**Seismic Walkdown Checklist (SWC)**

Peach Bottom Atomic Power Station Unit 2  
MPR-3815, Revision 3  
Correspondence No. RS-12-173

Equipment ID: SV-2-23A-4543

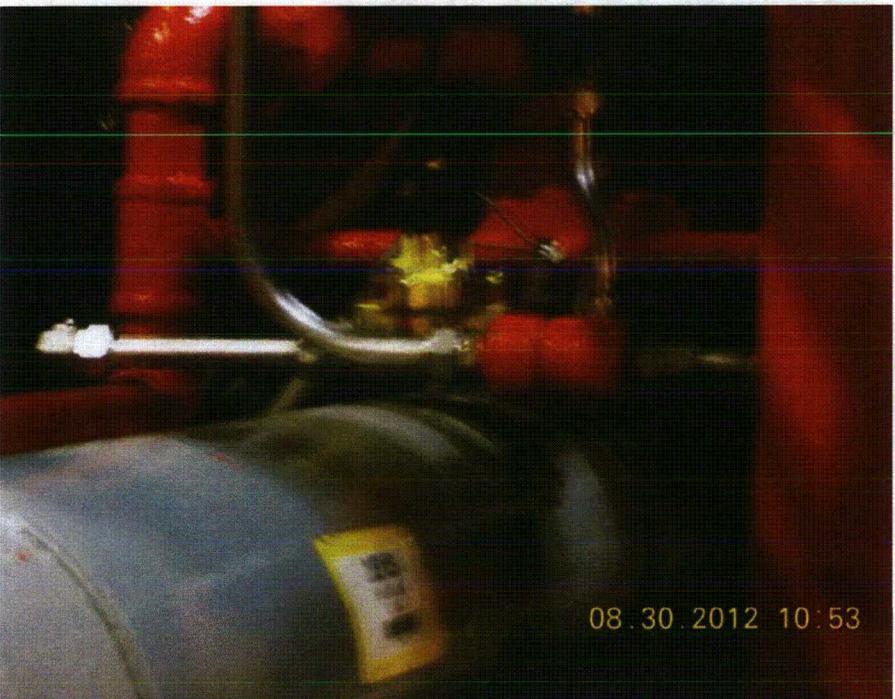
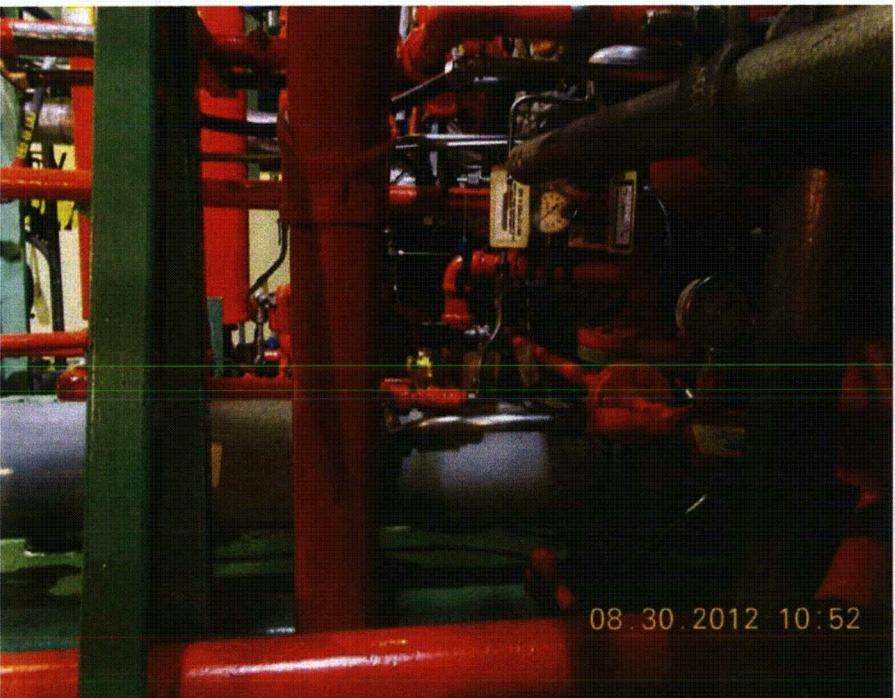
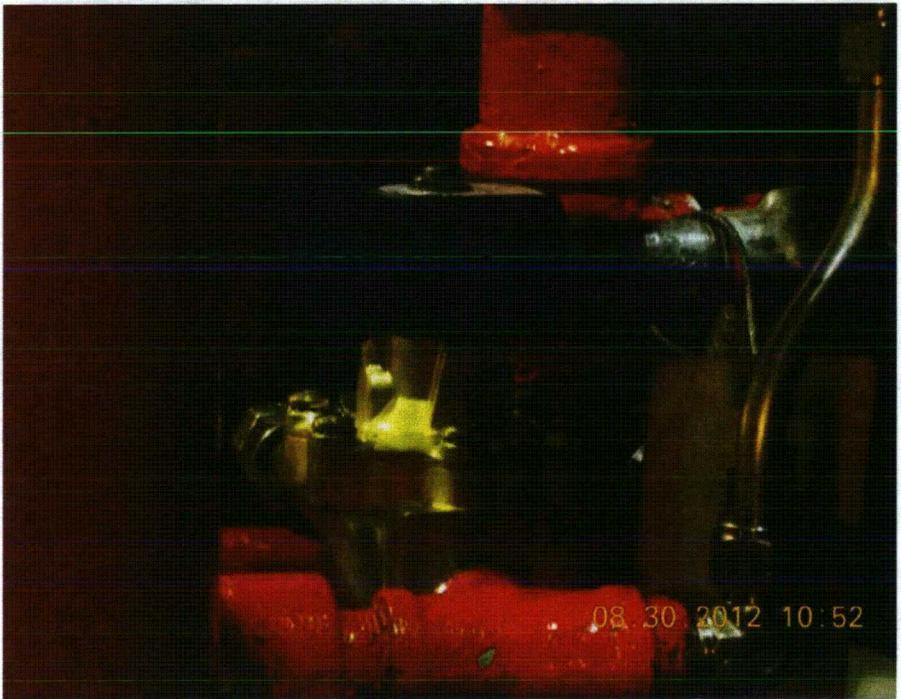
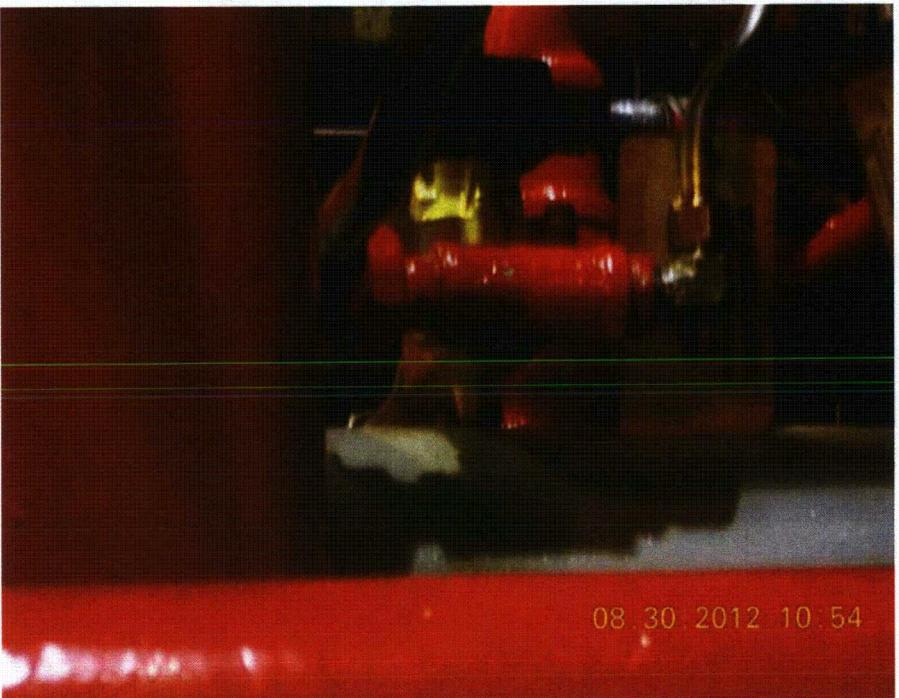
*Close proximity of valve to HPCI tube oil cooler likely to result in interference during seismic event, but not cause structural damage*
